River District Design Commission

NOVEMBER 12, 2020

RE: CERTIFICATE OF APPROPRIATENESS APPLICATION - 109 MAIN STREET

**Subject: Communication Test Summary Report and Remedial Plan
River District Tower
109 Main Street, Danville, Virginia
VRP Site #00665
Apex Project No. 768572-001**

Certificate of Appropriateness Request at 336 Main Street to replace existing building signs with acrylic lettering, aluminum lettering, bronze plaques, and LED channel letter signs.

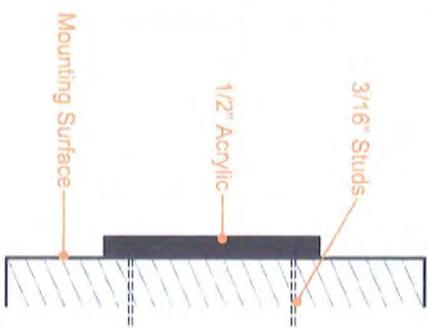
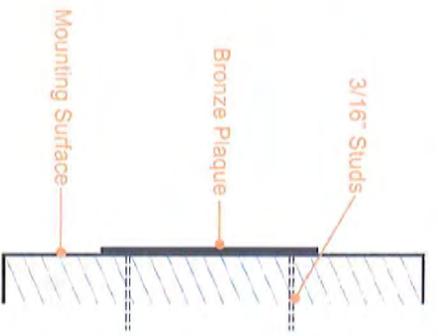
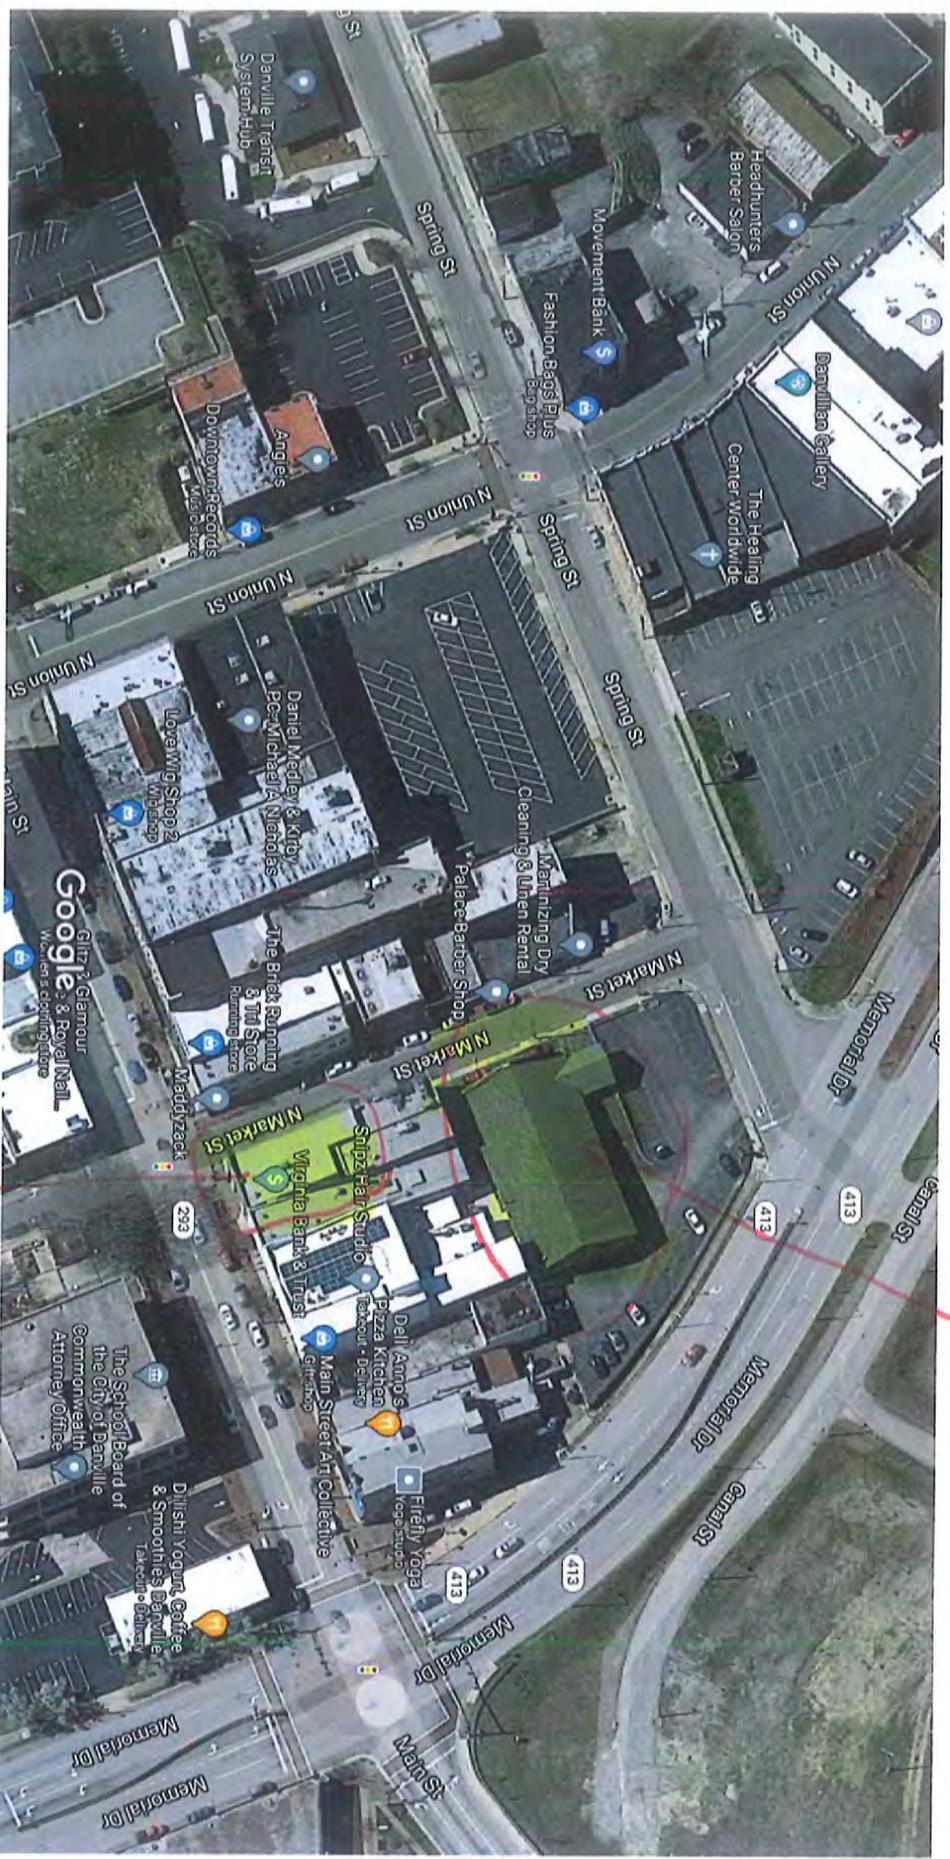
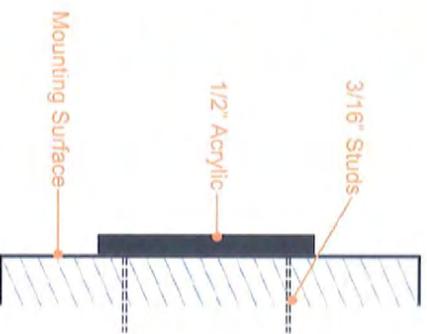
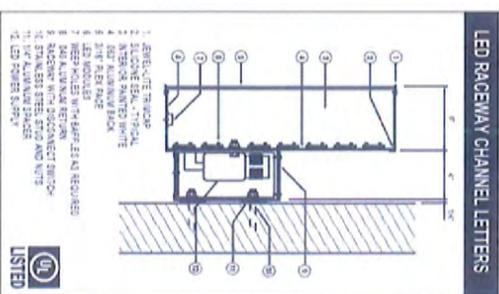
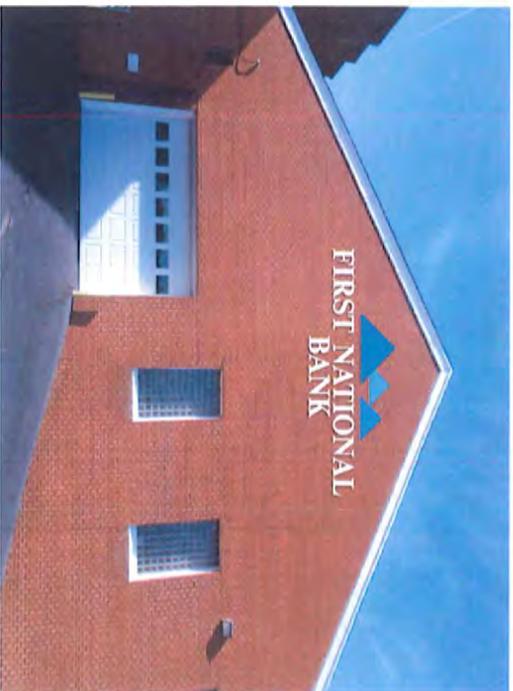
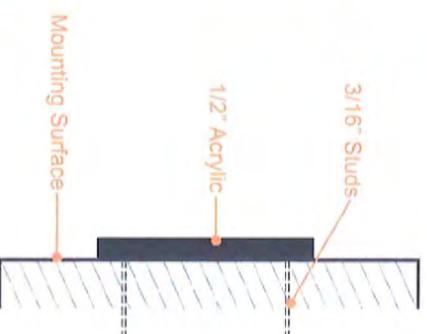
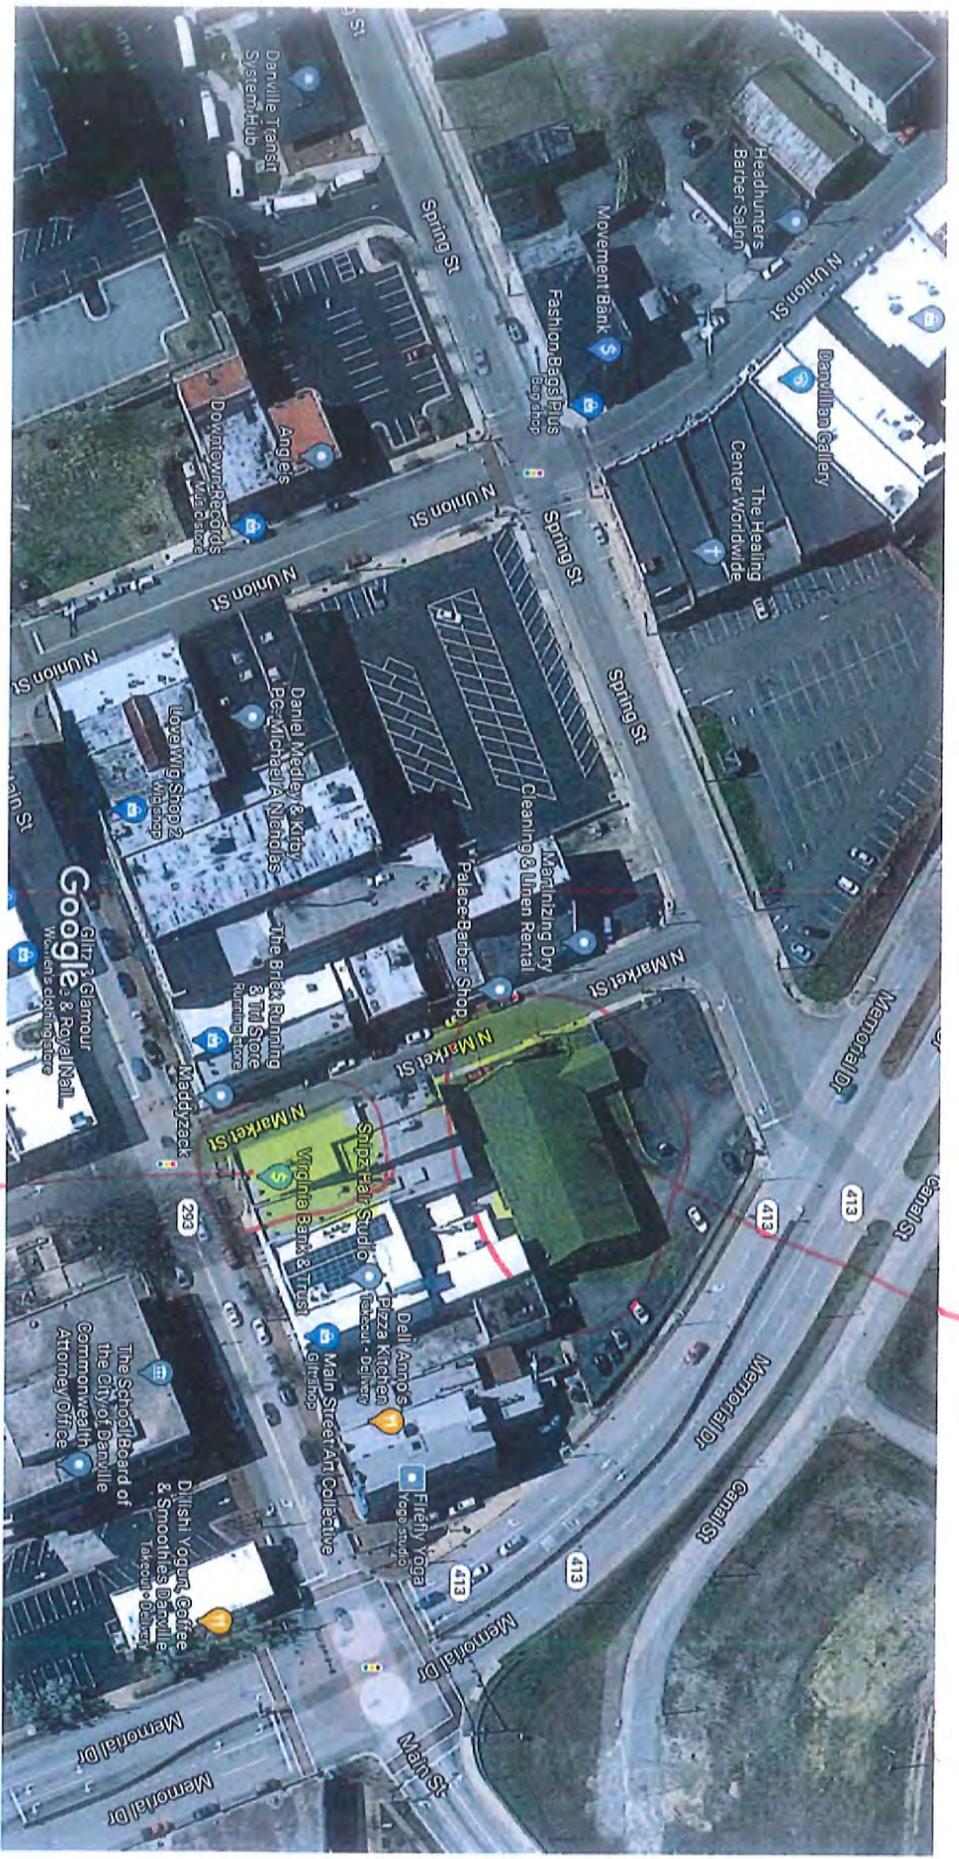
I recommend the River District Design Commission suggest an alternative to the proposed Building 2 sign 1 acrylic lettering and the Building 2 sign 2 should be halo lit instead of internally lit. If the RDDC is satisfied with the suggested alterations, then I recommend the River District Design Commission approve the Certificate of Appropriateness at 336 Main Street to replace existing building signs as submitted in their October 29, 2020 COA application incorporating staff recommendations.
